## DEPARTMENT OF TRANSPORTATION STATE OF GEORGIA

SUBJECT APPROVED REVISED CONCEPT REPORT

### REVISED PROJECT CONCEPT REPORT

Project Number: STP00-0000-00(543)

4 Lanes With a 14' Flush Median Troupeville Road/C.R. 276 to Ridgeland Road

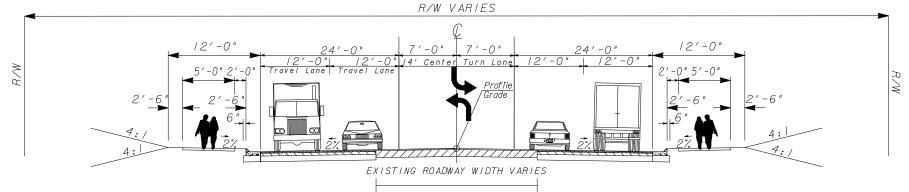
**Proposed features:** The 20' raised concrete median was revised to a 14' flush two-way center turn lane and the outside urban shoulder width was reduced from 16' to 12'. The 44' depressed median was revised to a 32' depressed median.

**Reason for Change:** The median type of the typical section was revised from a 20' raised concrete median to a to a five lane flush median section from Augusta Drive to Fellowship Lane due to the implementation of a VE recommendation. The five lane flush median section was extended from Augusta Drive to Troupeville Road/C.R. 276 to minimize right-of-way and environmental impacts and reduce construction and right-of-way acquisition costs.

4 Lanes With a 14' Flush Median and Sidewalk Ridgeland Road to Fellowship Lane

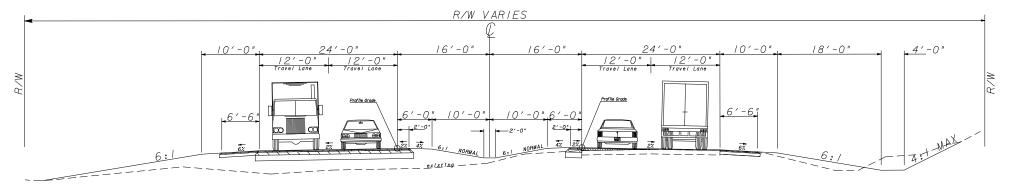
The outside urban shoulder width was reduced from 16' to 12' to minimize right-of-way and environmental impacts and reduce construction and right-of-way acquisition costs.

Due to the more urbanized areas, the outside urban shoulder width was reduced to 12' to minimize right-of-way and environmental impacts and reduce construction and right-of-way acquisition costs.
